San Angelo LE- ADA Evaluation

Report Date: 01/12/2024

LE-San Angelo TX, ADA Evaluation
3407 S Chadbourne St
San Angelo, TX 76904
Accessibility Evaluation
Inspection Date: 01/17/2023
Inspectors: Jessica Burke

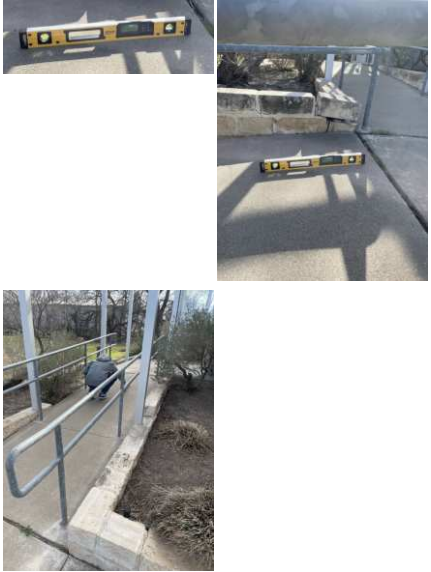
Finding Number	Area Description	Finding	As Built	Recommendation	Citation	Photos	Figure
3	Exterior of Property (Public) : Parking Lot (1 Space) 1 Labeled - Accessible Stall (Labeled)	The accessible parking space is missing the required markings. Vehicle spaces shall be marked to define the width, and shall have an adjacent access aisle.	Accessible parking stall borders faded on (R) side and missing on (L) side.	https://www.access-board.gov/ada/#ada-502_2	2012 TAS Section: 502.2 2010 ADAS Section: 502.2 2015 ABAAS Section: 502.1, 502.2		
4	Exterior of Property (Public) : Parking Lot (1 Space) 1 Labeled - Accessible Stall (Labeled)	The accessible parking space is missing the required ISA marking. A paved accessible parking space must include the International Symbol of Accessibility painted conspicuously on the surface in a color that contrasts the pavement.	N/A	N/A - Refer to Finding	2020 TDLR Section: 68.104 (a)(1)

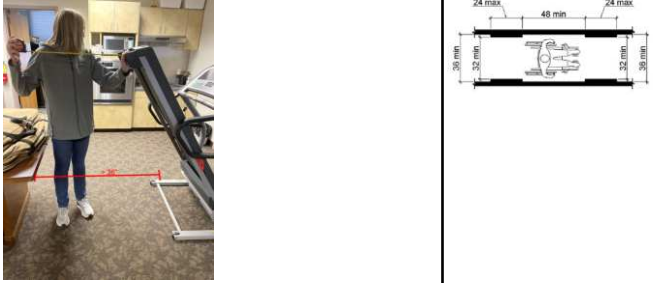
Finding Number	Area Description	Finding	As Built	Recommendation	Citation	Photos	Figure
22	First Floor Main Building LOBBY (Public): Entrance into Lobby - Interior Vestibule Door	The door is recessed greater than 8 inches deep with non-compliant latch side clearance. The width of the maneuvering clearance within a recess on the latch side greater than 8 inches deep must be as wide as the door plus an additional 18 inches on the latch side and in the same plane as the door . The maneuvering clearance must be flat (2% max. slope in any direction) and clear of obstructions.	Pamphlet shelf obstructing clear floor space requirement	https://www.access-board.gov/ada/#ada-404_2_4_3	2012 TAS Section: 404.2.4.3 2010 ADAS Section: 404.2.4.3 2015 ABAAS Section: 404.2.4.3		
23	First Floor Main Building LOBBY (Public): Lobby Area - Service Counter	Accessible counters are not provided for all the different types of sales and service counters available. At least one of each type of sales counter and service counter shall be accessible.	There is no accessible service desk at this location Toe clearance extends 11 inches	https://www.access-board.gov/ada/#ada-227_3	2012 TAS Section: 227.3 2010 ADAS Section: 227.3 2015 ABAAS Section: F227.3
